Addendum

Date	January 16, 2026
Project Name	Dexter Community Schools – Dexter High School New Field House
TMP Project No(s).	25026E
Bid Package No.	One(1) – PEMB
Addendum No.	One(1)

10 S4.1 TYPICAL EXTERIOR FOOTING
NOT TO SCALE

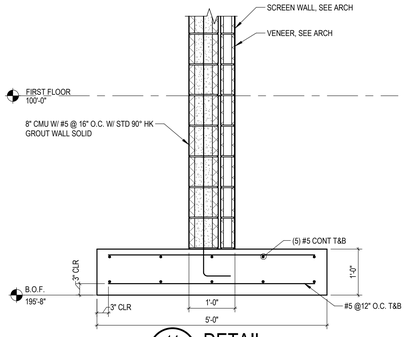
Item No.	**Structural Drawing Changes**
SD-1	Refer to Drawing No. S4.1 (reissued): A. Refer to Detail 10/S4.1. Revised pier and concrete tie depth as indicated. Please note, this was included in the RFI 11 response. B. Refer to Concrete Pier Schedule. Added top of pier elevations as indicated. Please note, this was included in the RFI 11 response.
SD-2	Refer to Drawing No. S6.1 (reissued): A. Refer to Detail 5/S6.1. Revised metal panel callout as indicated. Added note as indicated, please note this was included in the RFI 10 response. B. Refer to Detail 6/S6.1. Revised metal panel callout as indicated.

DRAWING NO.
A4.2

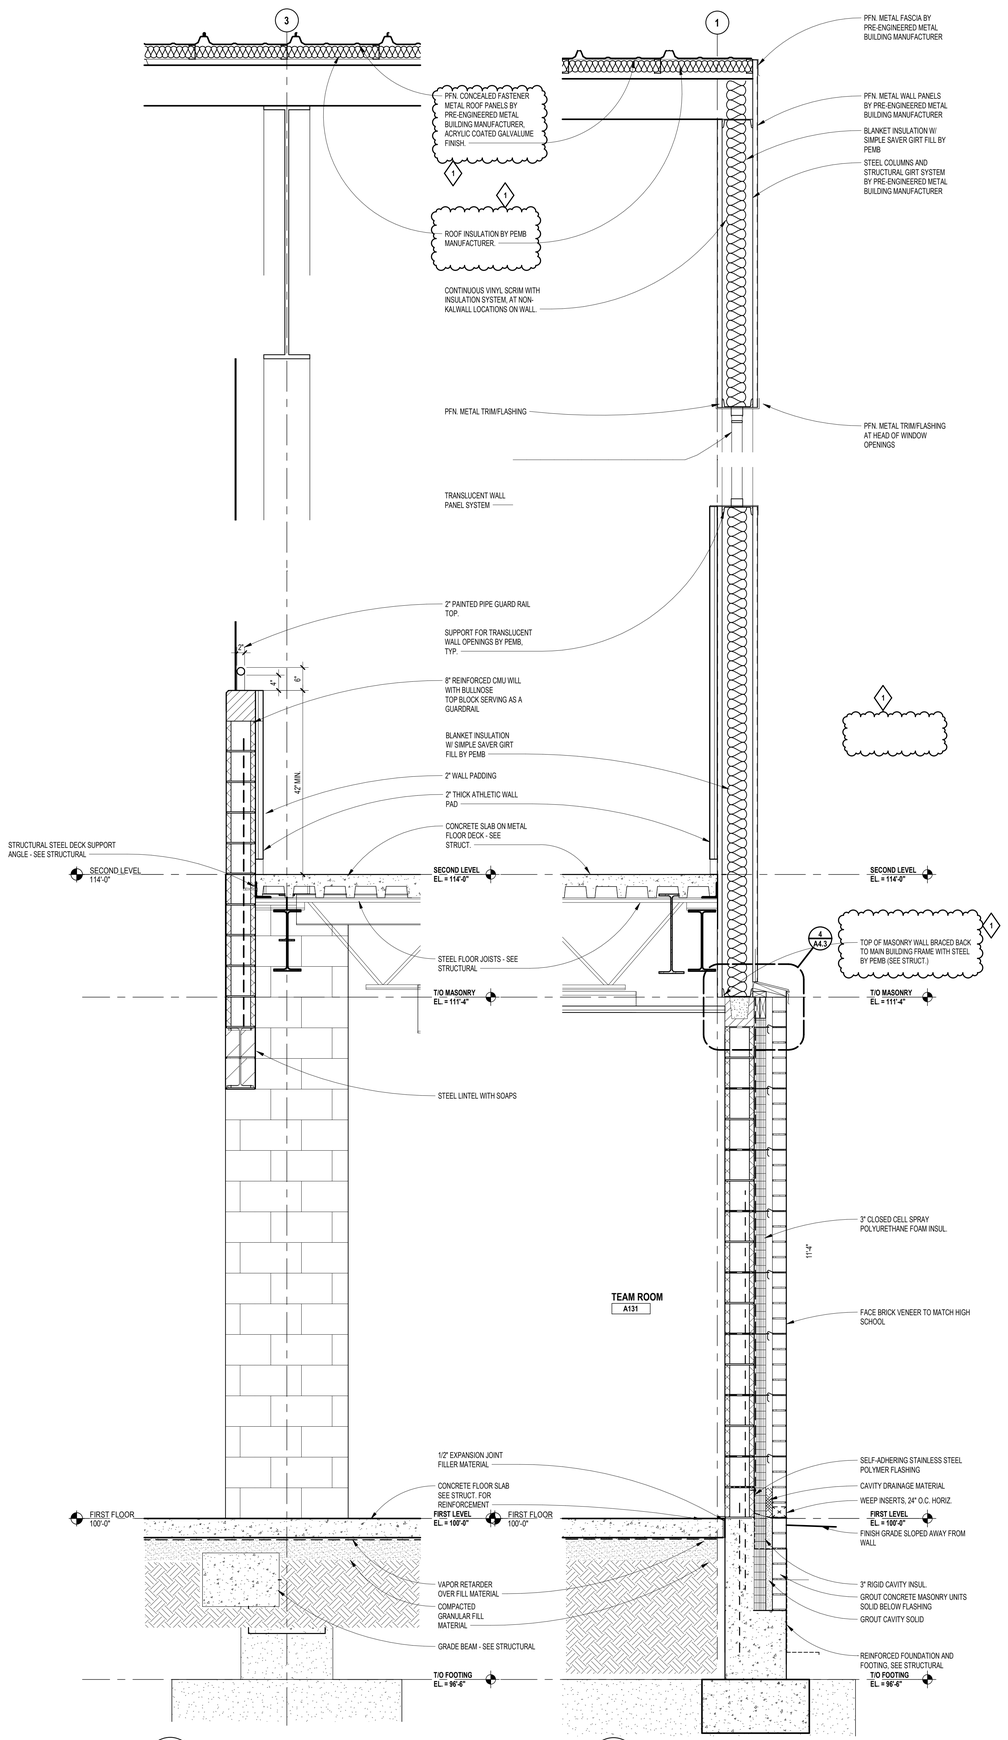
Item No.	**Architectural Drawing Changes**
AD-1	Refer to Drawing No. A4.2 (reissued): A. Refer to Detail 1/A4.2. Removed note referring to ACM panels. Revised roof deck notes, roof finish and top of masonry wall notes as indicated. B. Refer to Detail 2/A4.2. Removed note referring to ACM panels. Revised roof deck notes, roof finish and top of masonry wall notes as indicated. C. Refer to Detail 3/A4.2. Revised roof deck notes and roof finish notes as indicated. D. Note: these revisions are typical and should be applied to all wall sections where applicable.
